# BASILIAN FATHERS RESIDENCE ZONING MAP AMENDMENT 18.673 WITH PLANNED REZONING OVERLAY SITE PLAN 07-59

## PLANNED REZONING OVERLAY, IN CONJUNCTION WITH REZONING REQUEST 18.673

SUBJECT: **Basilian Fathers Residence – Revised Concept Plan**

Basilian Fathers Residence Planned Rezoning Overlay  
Rezoning 18.673 SP #07-59

## REDUCED CONCEPT PLAN

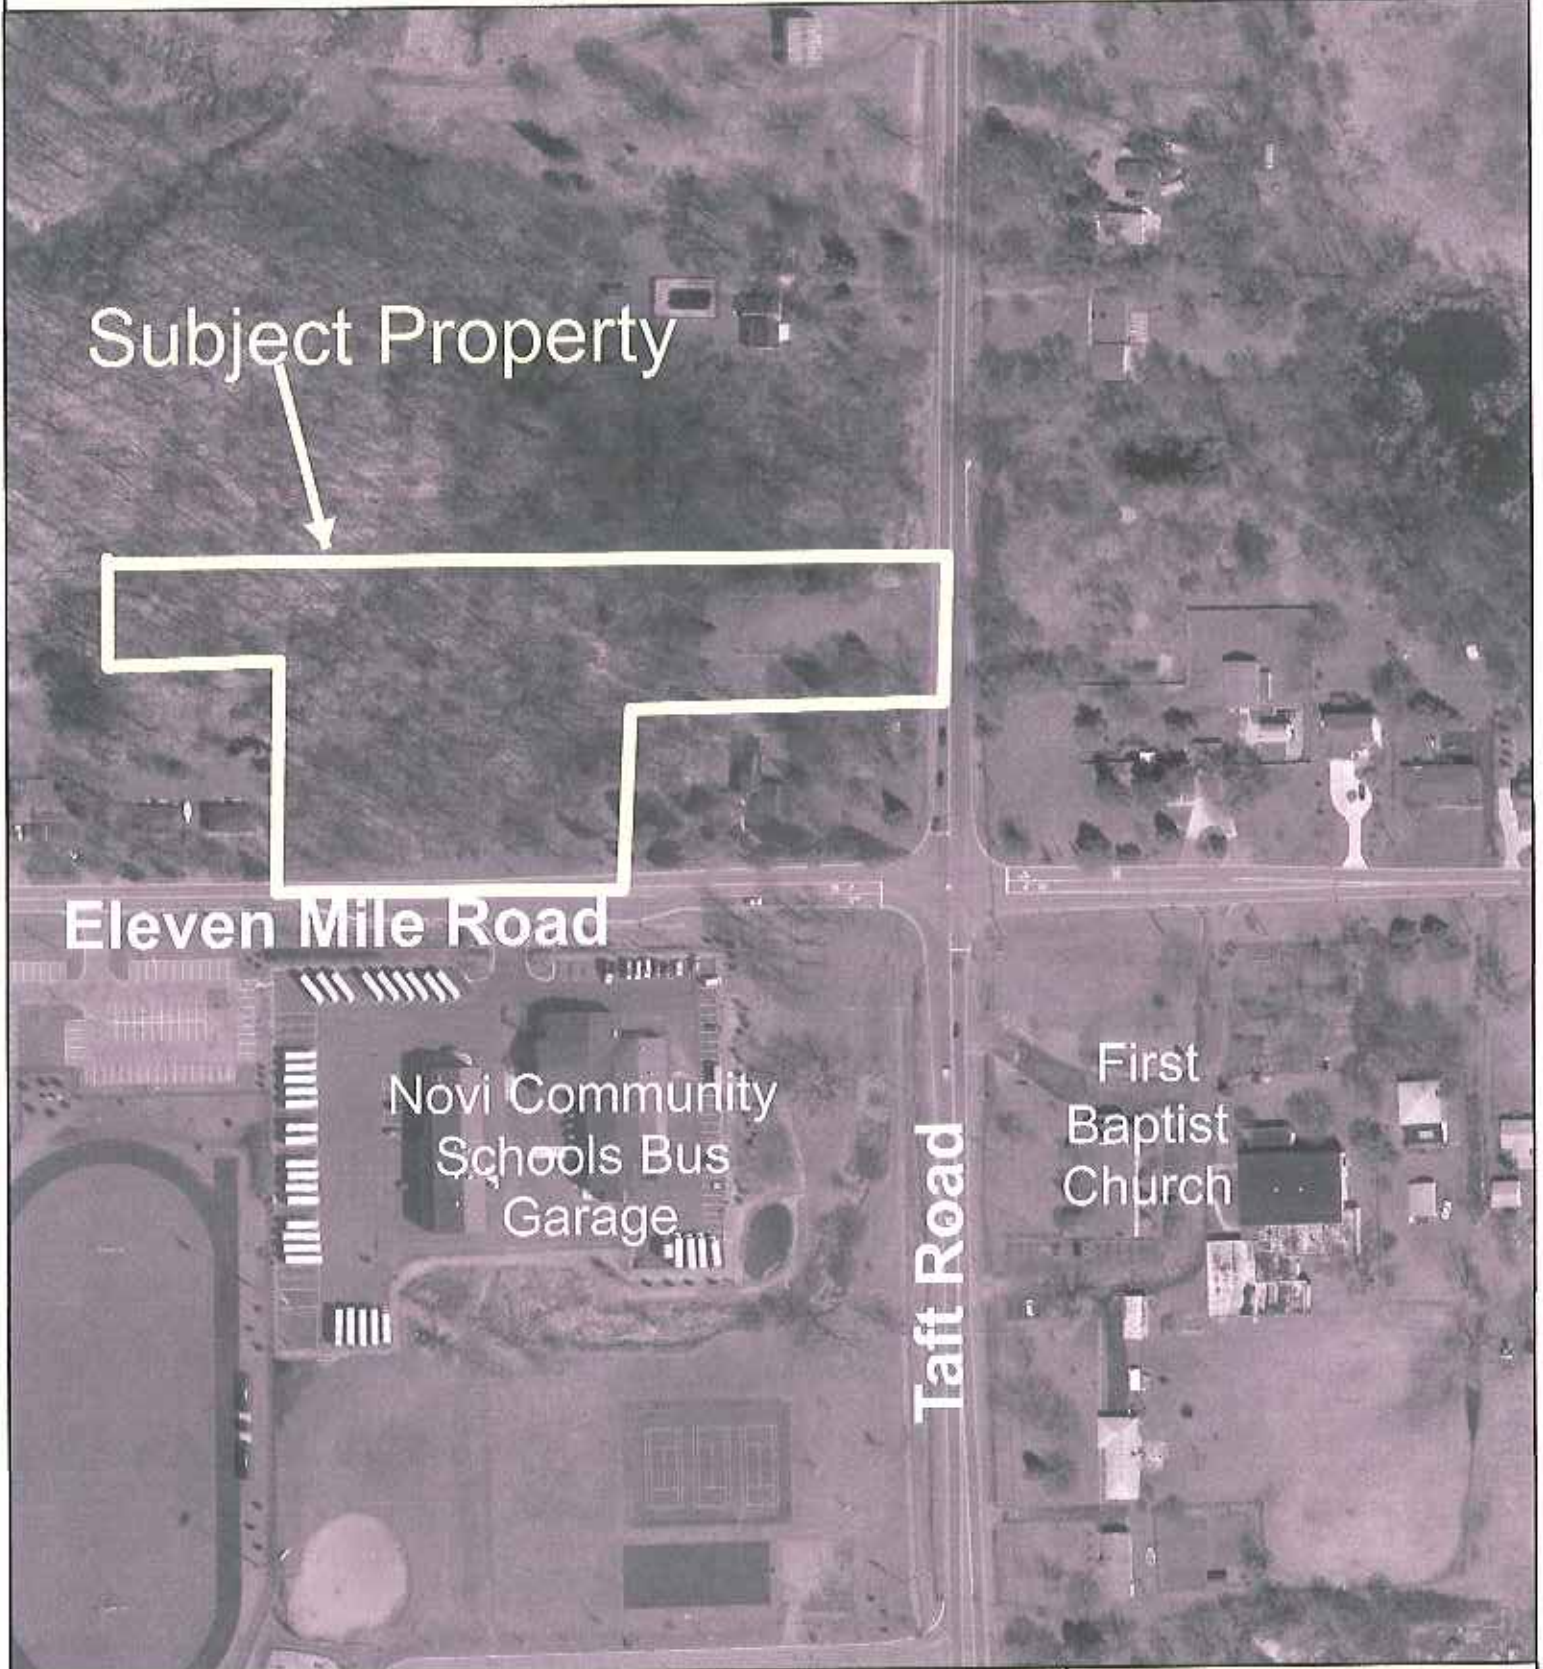
The Barrier Free Code indicates that one barrier free van accessible space should be provided for any parking area having one to twenty-five spaces. Twenty spaces are shown for the proposed residence. However, none of these spaces are barrier free. One barrier free van accessible space should be provided. **The applicant should indicate where this space will be provided on the response letter and a barrier free sign should be included on the plan.** The applicant may want to consider marking the 21' area on the north side of the building, just east of the center island as a van accessible space.

A five foot sidewalk is required along the Eleven Mile Road frontage and an eight foot sidewalk is required along the Taft Road frontage. The applicant has indicated that a sidewalk will be provided along Eleven Mile Road but has not indicated the size. No sidewalk is shown along Taft Road. **The applicant should show both required sidewalks on the plan and indicate the size of each sidewalk.**

1. **Location Map:** Location map denoting the location of the proposed development should be provided on the site plan.
2. **Sidewalk:** Sidewalk should be provided on the frontage of the proposed development along both 11 Mile and Taft Roads. A walking path should also be provided to the proposed building from these sidewalks.

6. **Parking Stalls:** Width of the parking stalls should be 9'. Width of the parking stalls adjacent to the turnaround areas should be 9' from the face of the curb. Such should be clearly labeled on the plan. The length of the parking stalls must be 19'.

- a. Parking Setbacks: Parking setbacks are at least 20 feet as required by RM-1 zoning and are shown on the Conceptual Site Plan dated "Rev. 1-16-08".

- b. Number of Parking Spaces: 14 parking spaces are required. 22 parking spaces are provided.
- c. Uncovered parking stalls are shown as 9 feet wide by 19 feet long with a 24 foot wide aisle. Covered parking stalls are shown as 10 feet wide by 20 feet long on Conceptual Site Plan dated "Rev. 1-16-08".

- d. Barrier Free Spaces: A van accessible barrier free parking space 16 feet wide by 19 feet deep has been shown on Conceptual Site Plan dated "Rev. 1-16-08".

Other accessory structures, if any, will be shown on the Preliminary Site Plan submittal.
- g. Lighting: Photometric Plan of lighting will be included on Preliminary Site Plan submittal.
- h. Sidewalks: An 8 foot wide bike path along Taft Road frontage and a 5 foot wide sidewalk along Eleven Mile Road have been shown on Conceptual Site Plan dated "Rev. 1-16-08". As a PRO public benefit, the sidewalk and bike path have been extended to the intersection of Eleven Mile Road and Taft Road.
